Perry Nuclear Power Plant
Docket Nos. 50-440; 50-441
Response to Draft SER
Structural Engineering Branch

Perry Nuclear Power Plant
Intake and Discharge Tunnels

Responses to Additional Information
Requested by the NRC - March 30, 1982

FIGURE 10. LONGITUDINAL STRESSES RESULTING IN PERMANENT LINING FROM GROUT LOAD G

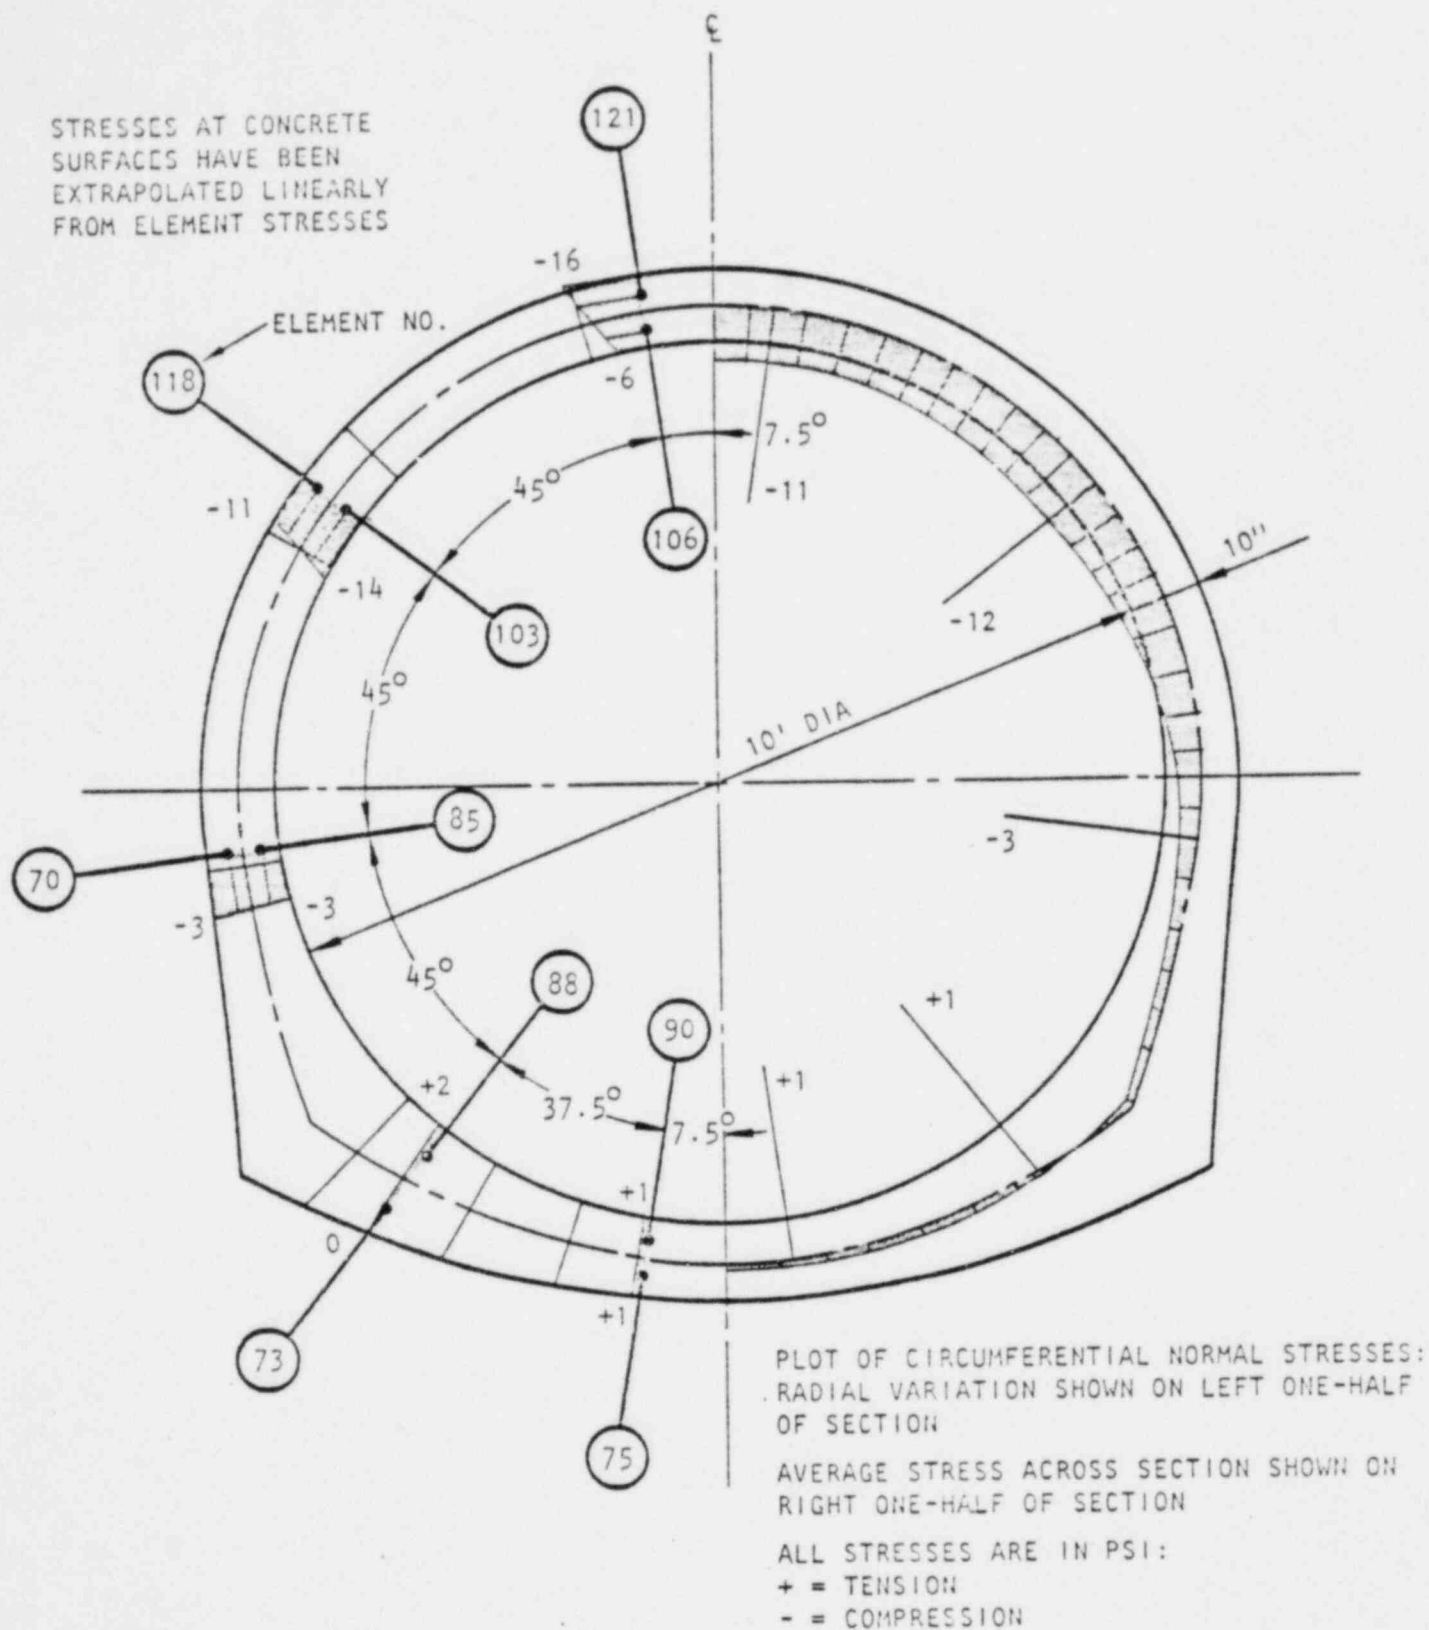
- 5. We need additional information and reference materials pertaining to your longitudinal tunnel analysis procedures. Also assess and discuss your analysis approach with respect to the applicable requirement of SRP Section 3.7.3.

Comparison of the longitudinal stresses given in Figures 10 and 11 for the grout load G and the ground load H' with the stresses resulting from the fluid pressures indicates that the longitudinal static load stresses are quite low and vary from tensile stresses of less than +50 psi to compressive stresses of about -100 psi. This statement neglects temperature stress effects. The temperature and seismic stresses, however, are sufficient to cause transverse cracking. The designer is, therefore, faced with four alternatives. Recognizing that transverse temperature cracks will result in a slight local increase in stress in the transverse section, but will not impair the load-carrying capacity of the tunnel, three of the alternatives involve relieving the longitudinal temperature stresses through the use of transverse joints or cracks. These alternatives are (1) provide transverse construction joints at regular intervals along the longitudinal axes of the tunnels; (2) provide control joints rather than construction joints; and (3) provide no joints but let transverse cracks develop at random. The fourth alternative is to control the temperature cracks by the use of longitudinal temperature reinforcing steel. These alternatives are prerogatives of the designer. If the longitudinal stresses are to be carried by reinforcing steel, the stresses that must be considered are given in Figures 21 through 27 for the seven loading conditions considered in this analysis.
